Model: <b>Martini-C4</b>	Date: 30-Apr-09	No.: RD062001
--------------------------	-----------------	---------------

Subject: Printer SP Bit Switch #5-7		Prepared by: Koji KY Yamamoto	
From: 2nd Tech. Support Sec. Service Support Dept.			
Classification:	<input type="checkbox"/> Troubleshooting	<input type="checkbox"/> Part information	<input type="checkbox"/> Action required
	<input type="checkbox"/> Mechanical	<input type="checkbox"/> Electrical	<input checked="" type="checkbox"/> Service manual revision
	<input type="checkbox"/> Paper path	<input type="checkbox"/> Transmit/receive	<input type="checkbox"/> Retrofit information
	<input type="checkbox"/> Product Safety	<input type="checkbox"/> Other ( )	<input type="checkbox"/> Tier 2

Martini-C4 does not need BitSw#5-7 because it prints on Letterhead correctly without it. Please correct your Service Manual as follows.

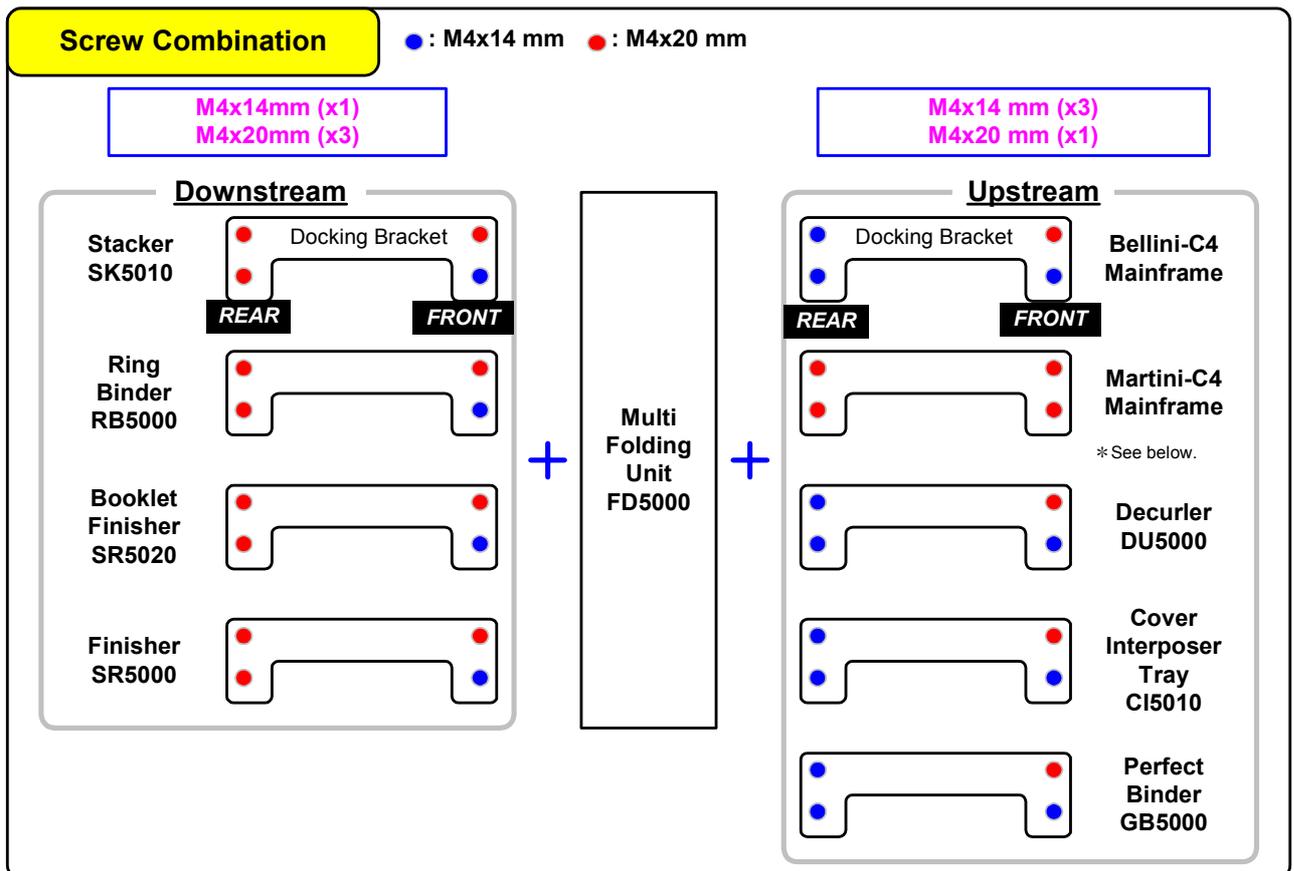
To avoid the problem, please replace (exchange) the screws for the upstream docking bracket and the downstream docking bracket as shown in the diagram below.

Upon design change, Multi Folding Unit will be attached with total of 8 screws (4 each of M4x14 & M4x20).

The installation guide and service manual will be revised accordingly.

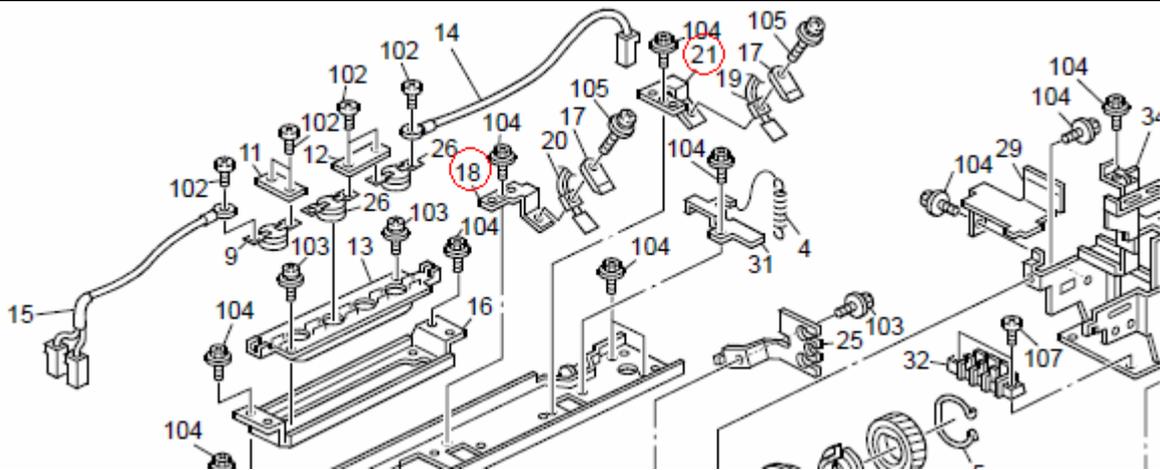
If the symptom occurs:

1. Clean the middle and rear thermistors.
2. If the SC still occurs even after cleaning the thermistors, replace the thermistor brackets with the new parts in the table below.

**Note:** This will secure the thermistors in the correct position, ensuring that they can detect the roller temperature correctly.

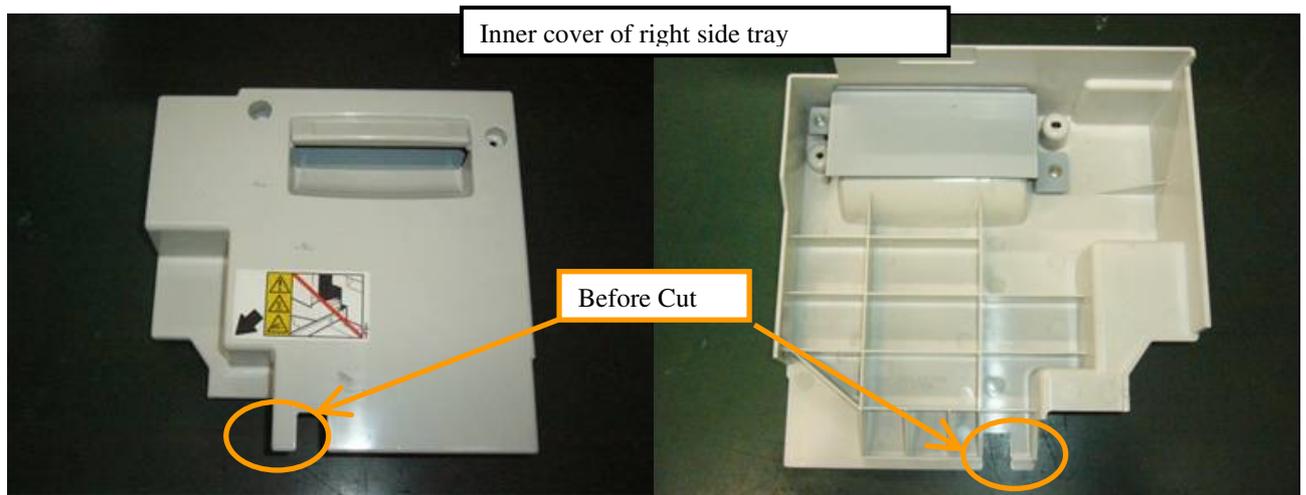
**SOLUTION:**

1. Confirm that the tandem tray stopper is broken. If it is, replace it.
2. Make a cut-out in the inner cover, as shown in the photo below **or replace with the new inner cover (D0626755).**

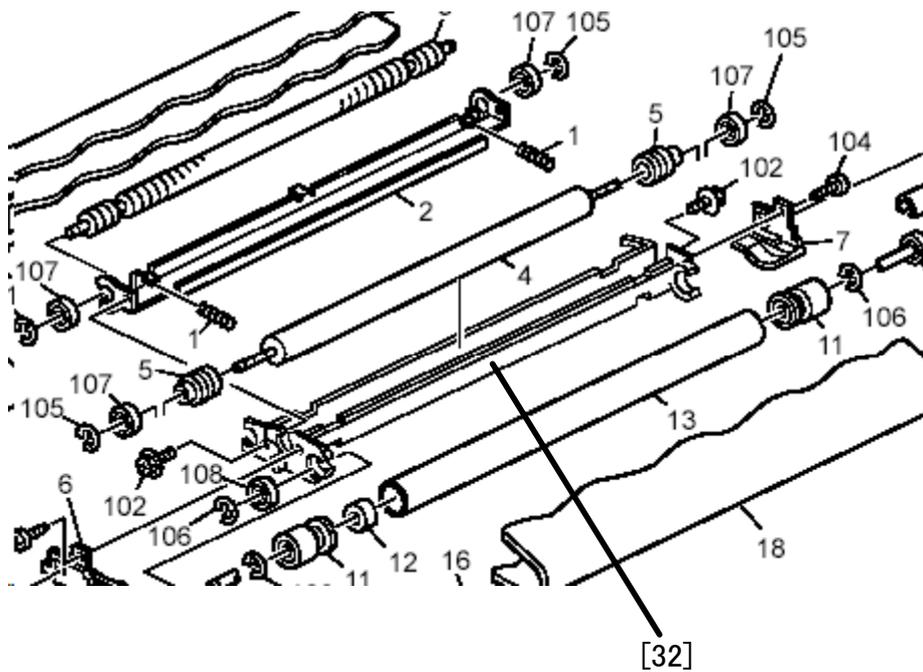
Old part number	New part number	Description	Q'ty	Int	Page	Index	Note
	D4123111	HOUSING:TRANSPORT BELT:SCANNING	1	-	37	32*

**Change/Reason:** The part numbers for the housing bracket was missing from the Parts Catalog (pg. 37, index 32\*).

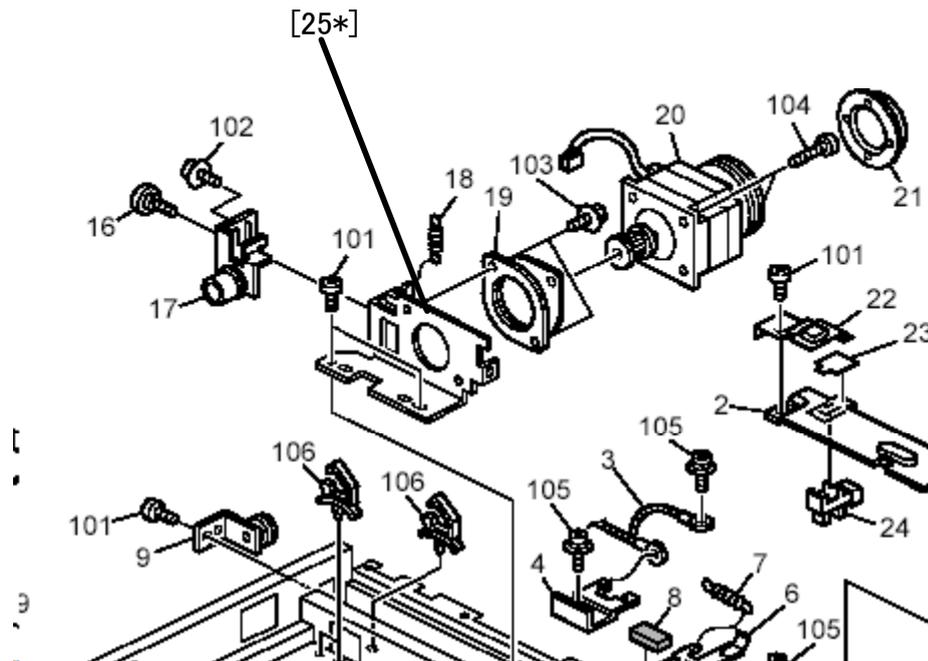
Old part number	New part number	Description	Q'ty	Int	Page	Index	Note
	D0621707	BRACKET:MOTOR	1	-	55	25*

**Change/Reason:** The part numbers for the housing bracket was missing from the Parts Catalog (pg. 55, index 25\*).

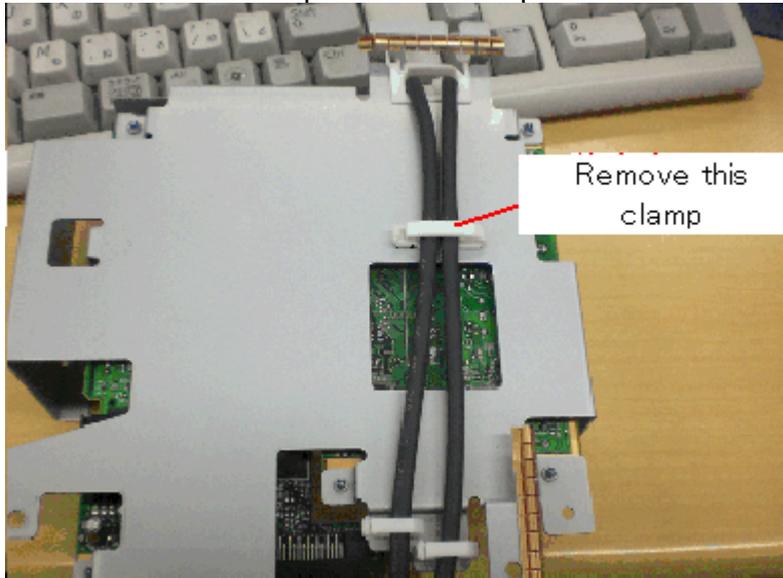
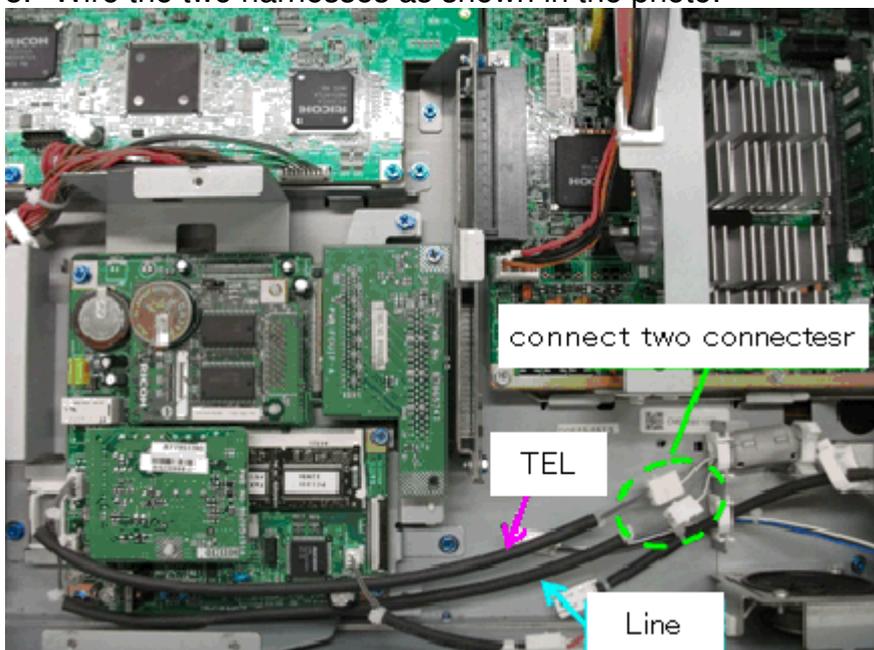
Do the following to ensure that the MBU connector stays firmly in place.

1. Remove the fax unit (3 screws).
2. Remove the clamp shown in the photo.

3. Wire the two harnesses as shown in the photo.

### Attachment Procedure

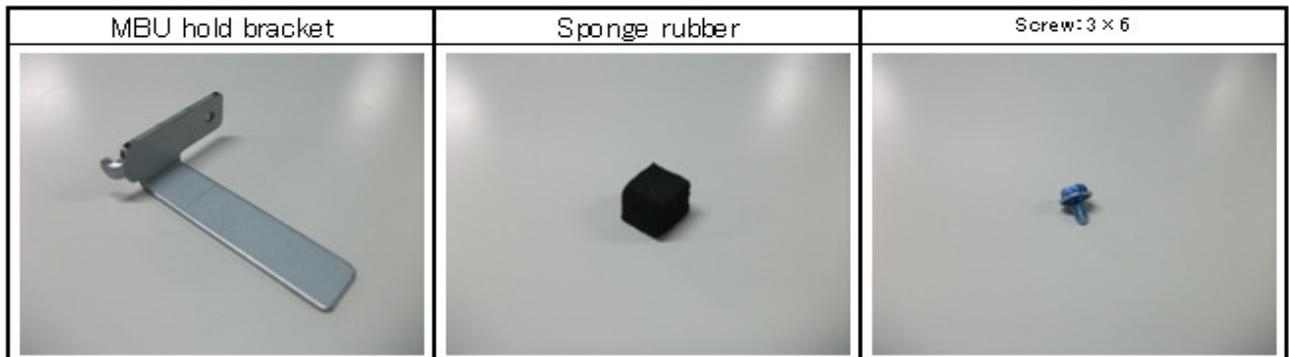
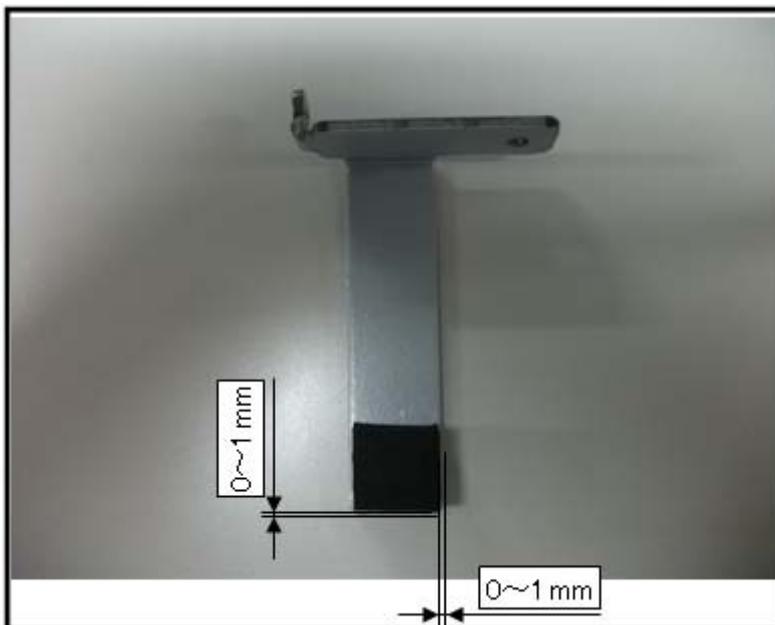
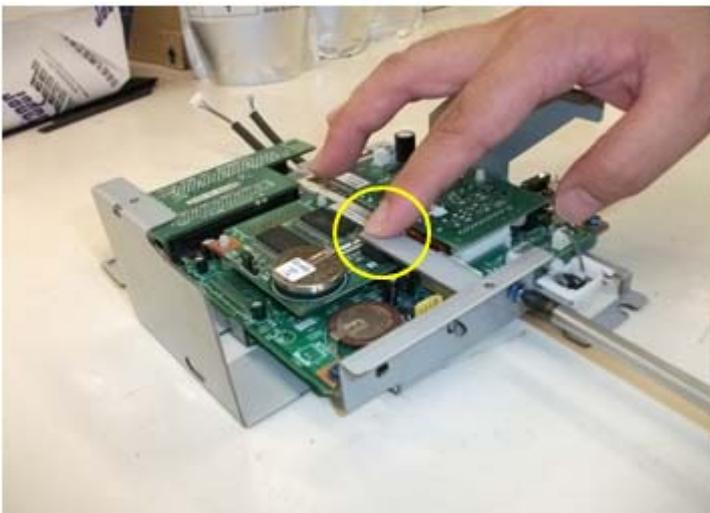
**See the attachment procedure below**

1. Attach the sponge rubber to the MBU holding bracket.

- Hold the bracket down while you tighten the screw, as shown in the photo below.
- Use the two holes circled in pink in the photo above (Step 3), inserting the screw in the side hole.

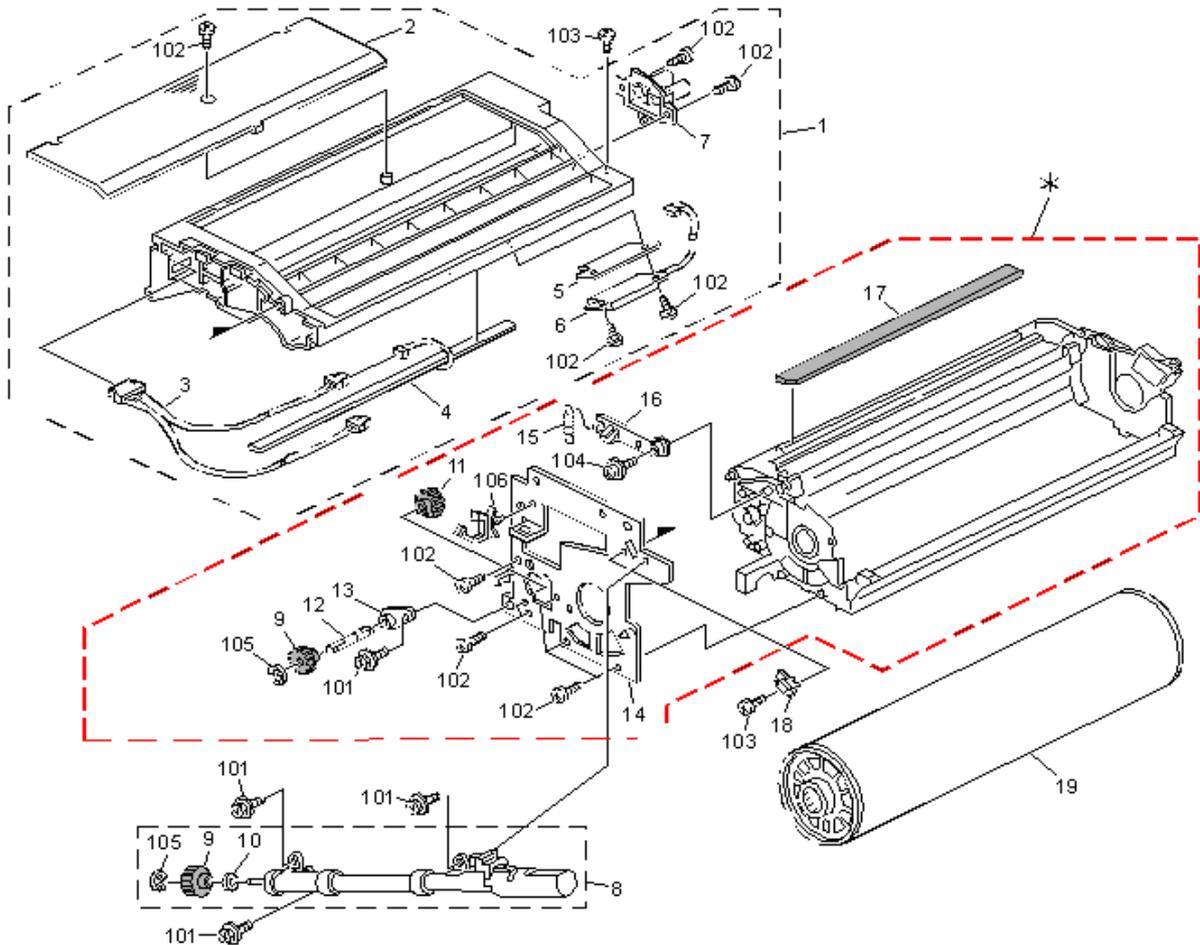
**Change/Reason:** The picture was wrong.

**22. Tandem Tray 1 (D062/D063/D065/D066)**

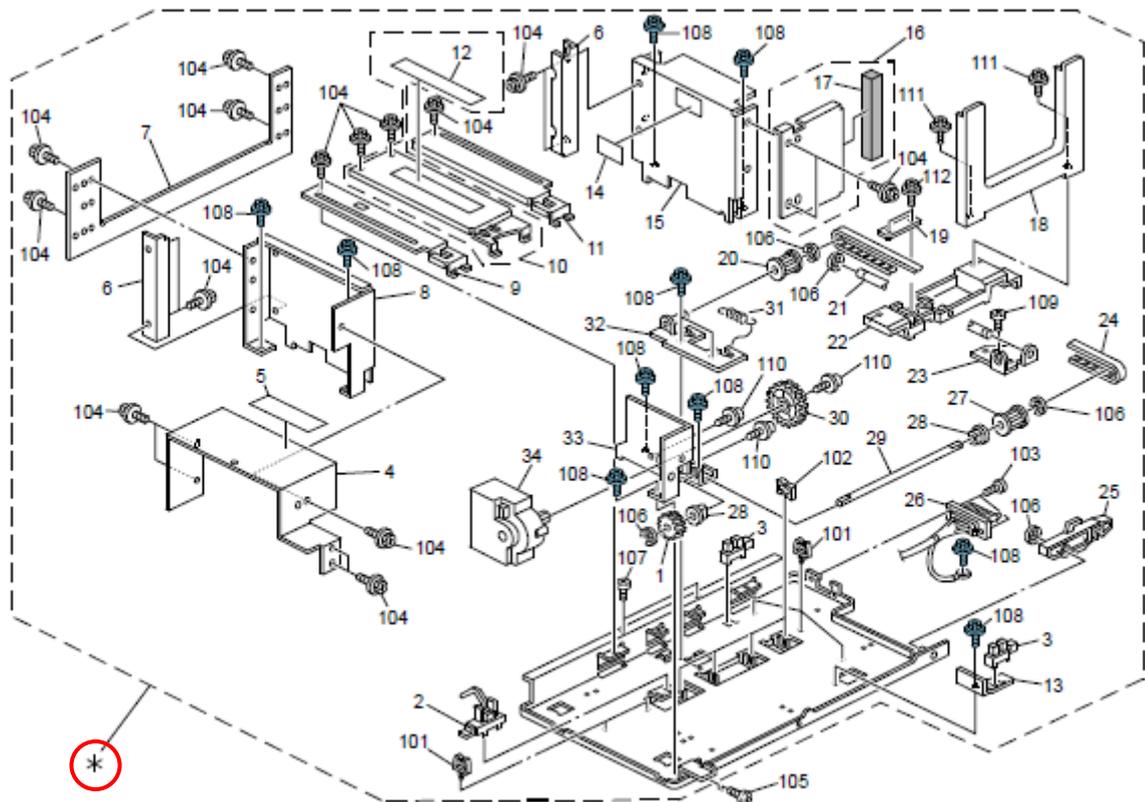
Part number	Description	Q'ty	Page	Index	Note
D0626625	Tandem LCT: Left: Letter: Ass'y	1	59	*	-
D0626603	Tandem LCT: Left : Ass'y	1	59	*	-

**Change/Reason:** Tandem LCT: Left :Ass'y for A4 size (P/N:D0626603) was added to the parts catalog.

**24. Tandem Tray 3 (D062/D063/D065/D066)**

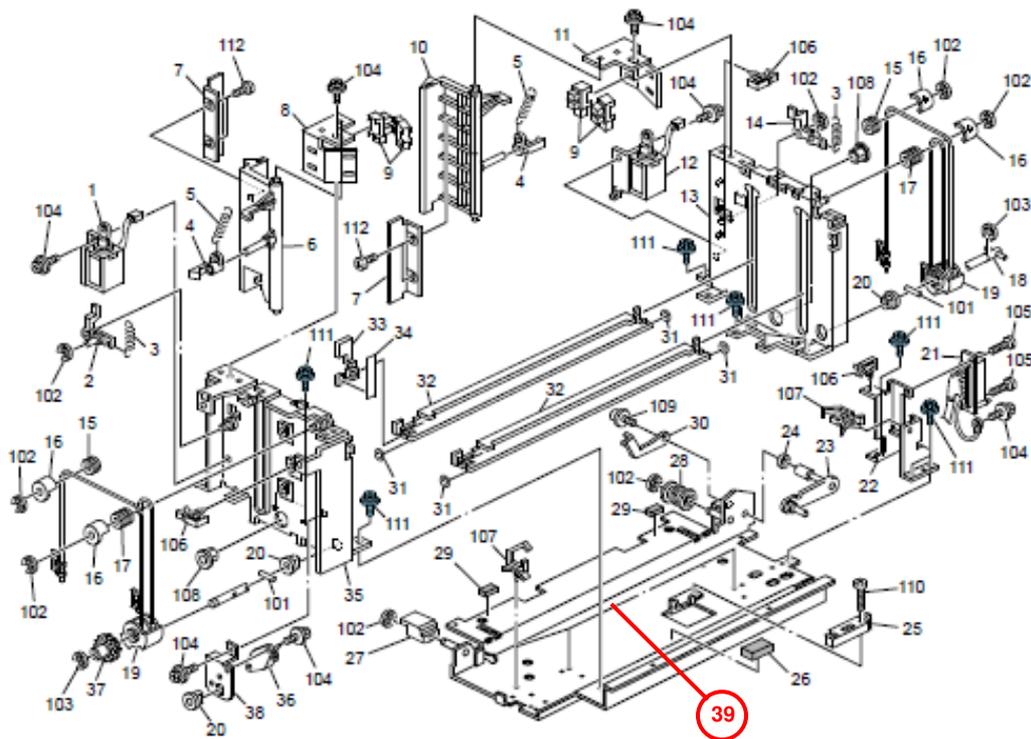
Part number	Description	Q'ty	Page	Index	Note
D0626852	BASE:TANDEM LCT: RIGHT: ASS'Y	1	63	39	New Index

**Change:** This part was newly registered as a service part.  
**Reason:** To meet a request from the field.

**24. Tandem Tray 3 (D062/D063/D065/D066)**

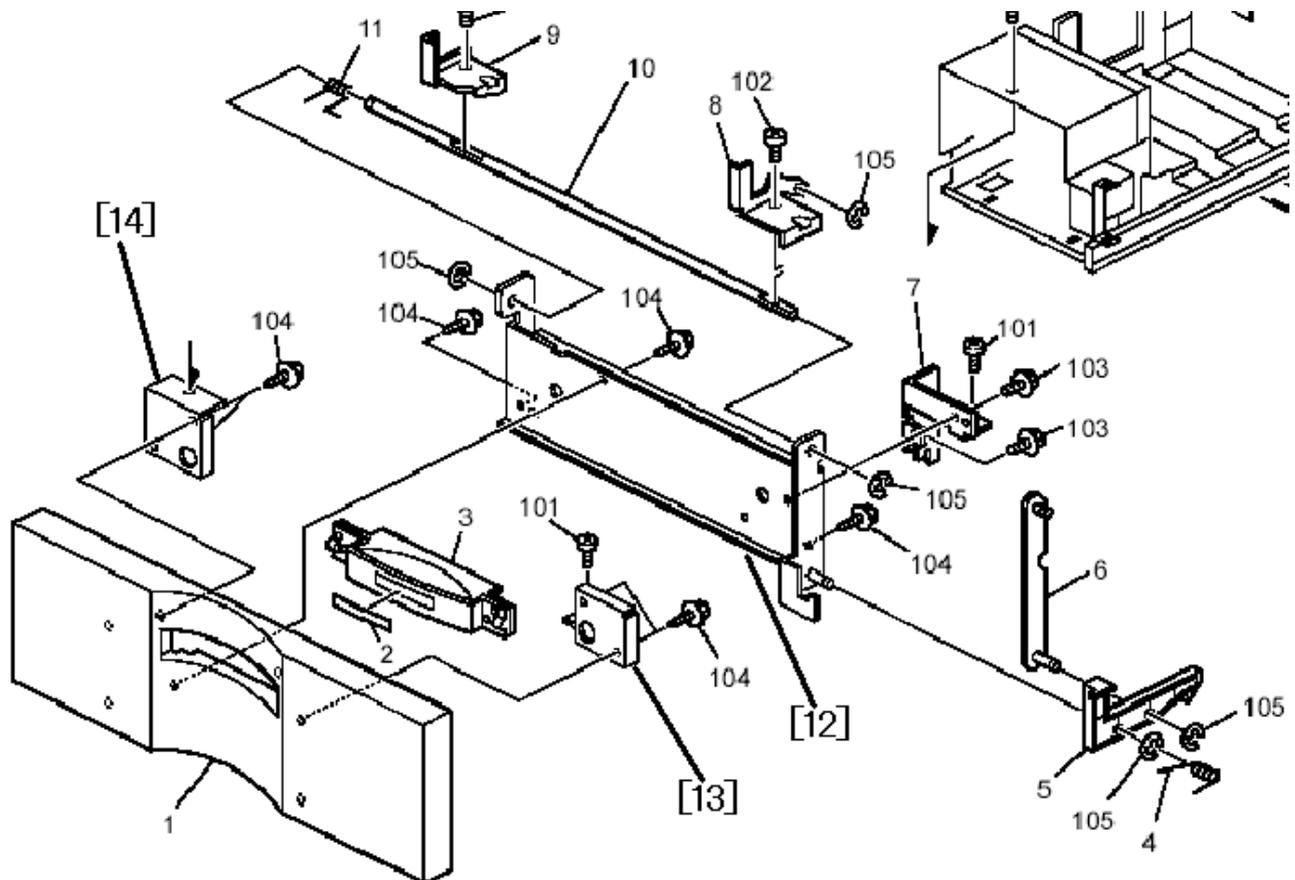
Part number	Description	Q'ty	Page	Index	Note
D0626707	BASE:STOPPER:TANDEM LCT:PEEN	1	22	12	New Index
D0626716	BRACKET:GRIP:TANDEM LCT:LEFT	1	22	14	New Index
D0626717	BRACKET:GRIP:TANDEM LCT:RIGHT	1	22	13	New Index

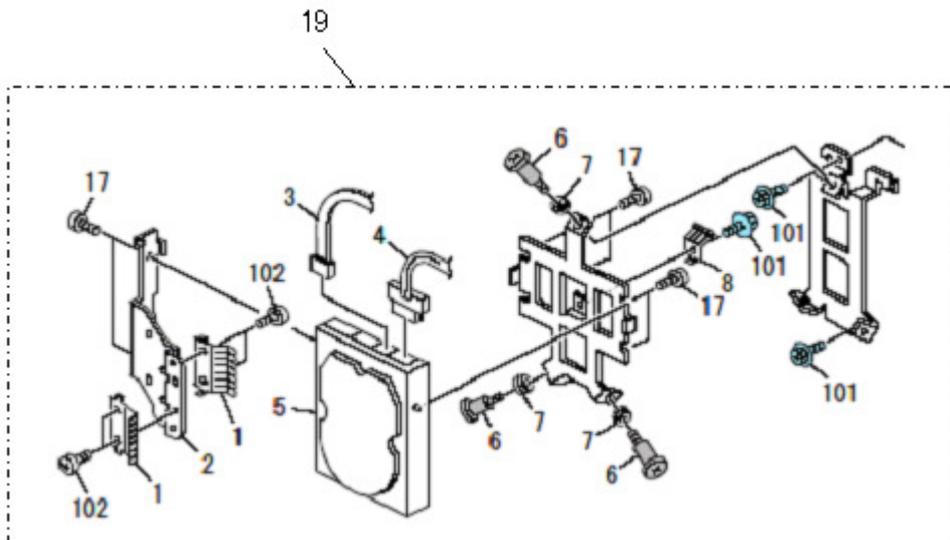
Old part number	New part number	Description	Q'ty	Int	Page	Index
M0265760	D0295793	HDD:WD:320GB:63N9A0	1	O/O	153	5
-	D0625906	HDD: ASS'Y	1	-	153	19*
